Report of Staff Recommendation

File No.: 2-A-23-TOB

Request: BUILDING PERMIT

Proposed Land Use: New office-warehouse building in existing office development

BLDG.1 - ELEVATIONS + SIGNAGE

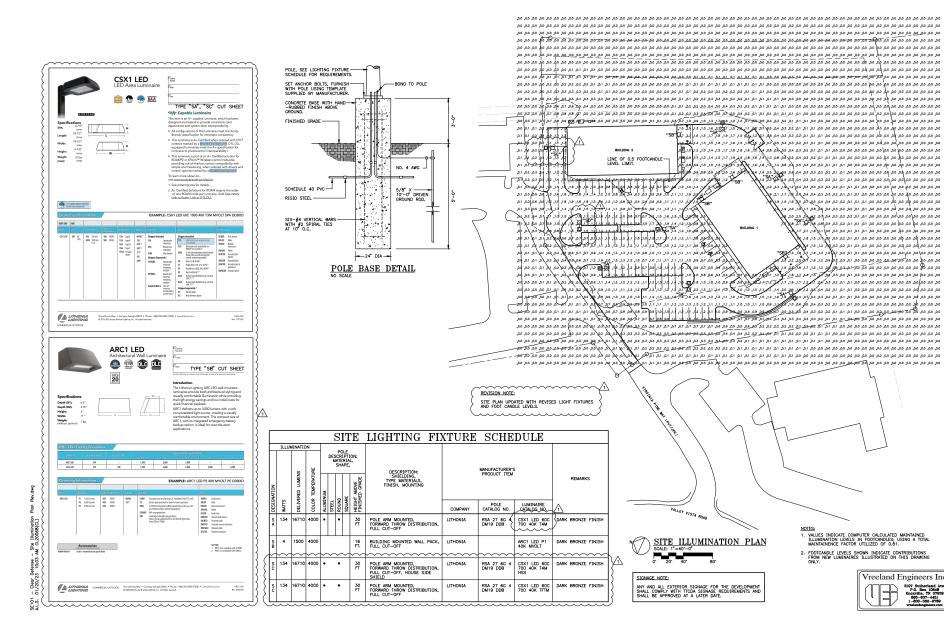
- 12) Both buildings feature a combination of architectural metal panels on the walls of the main level. Panels resembling wood are applied in a decorative manner as an outer shell with a sculpted curve reaching from the ground to the far upper corner of the buildings, and this feature is on the longest, front-facing facades. Both buildings also feature a covered portico features slanted columns capped with a flat roof. Building 1 has a raised area emulating a second floor on the south side of the building where the building entry is located.

LANDSCAPE PLAN SCALE: 1" = 20"

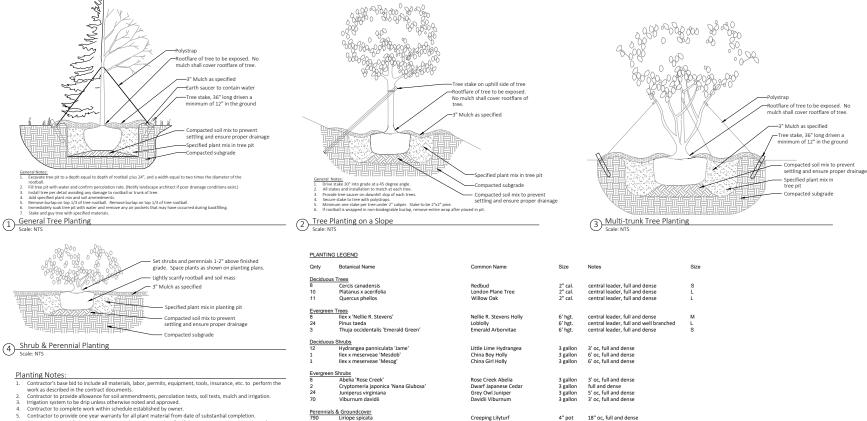
- 13) The proposed landscape plan features plantings around the subject building and site and within parking areas. The proposal meets the TTCDA Design Guidelines. A landscape plan for the phase 2 building will be submitted with building plans at a future time.
